INTERSTATE BUSINESS PARK SUBDIVISION
 P.O.A.D.P.

INFORMATION SHEET FOR
PRELIMINARY OVERALL AREA DEVELOPMENT PLAN
(P.O.A.D.P.)

Re: Interstate Business Park Preliminary Plan
 P.O.A.D.P.
 File #: 85-18-59-80

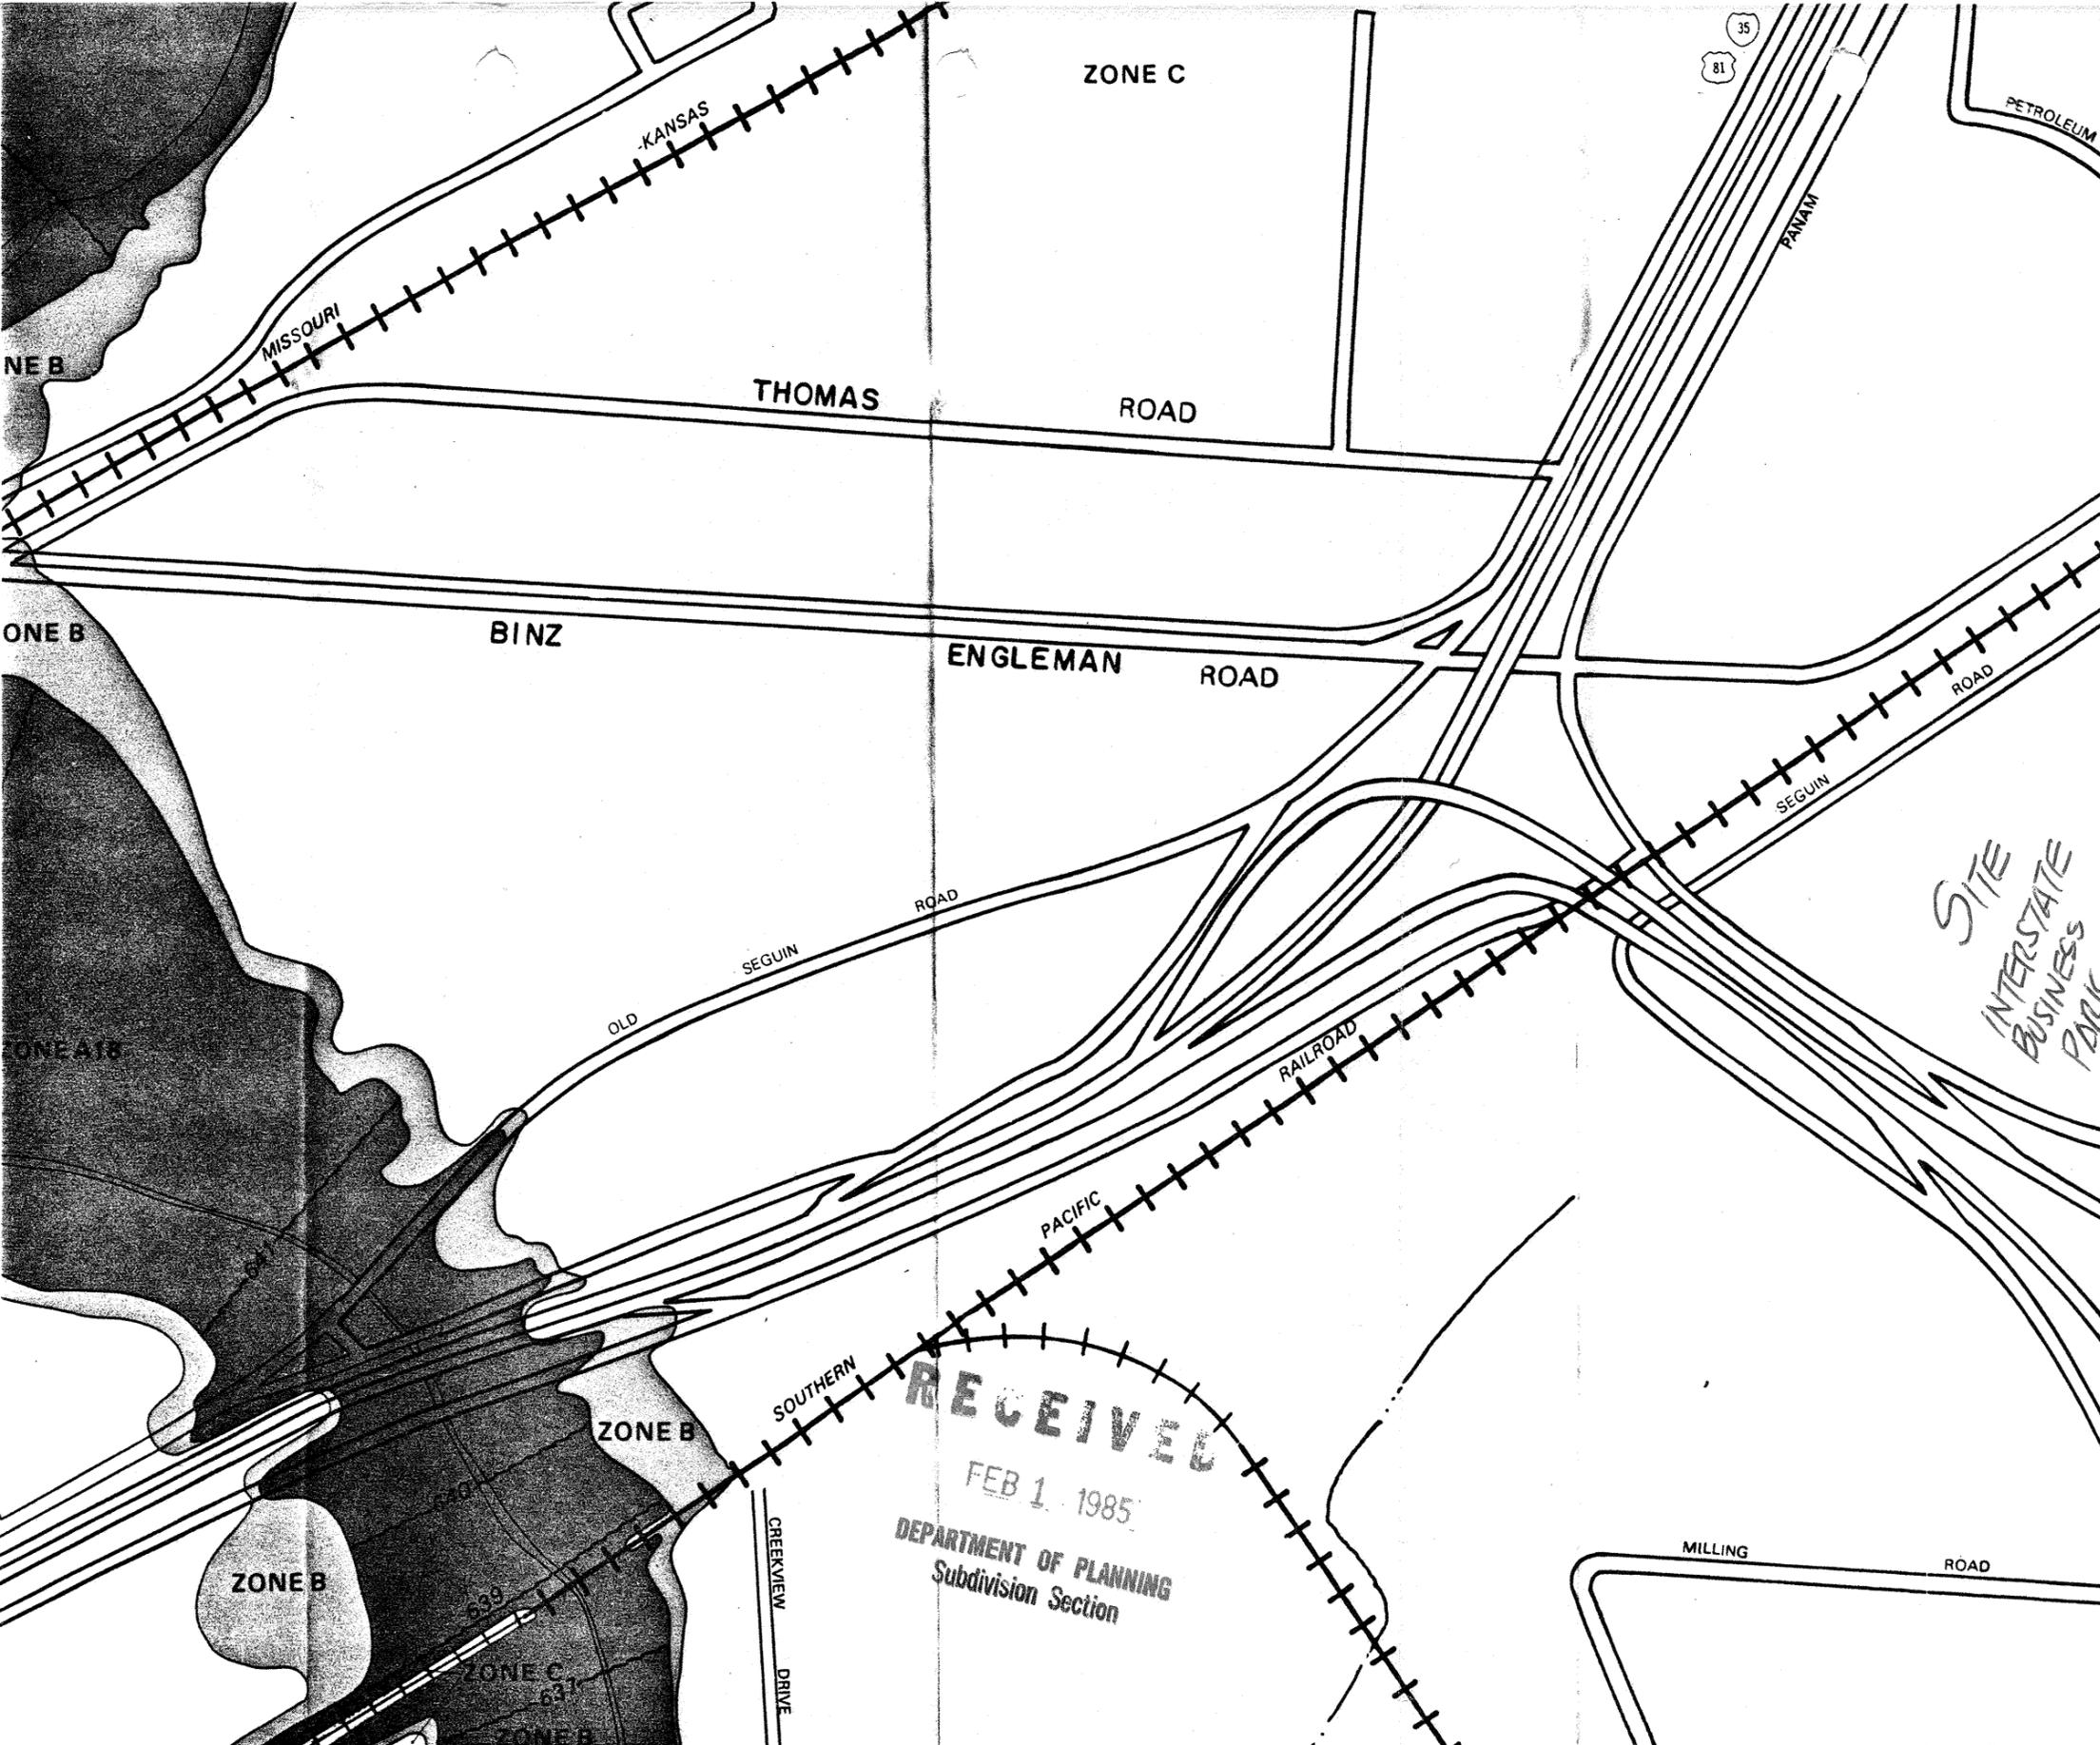
COMMENTS: called Gp & requested required info. paving widths (60' row),
average, flood plain salado creek.
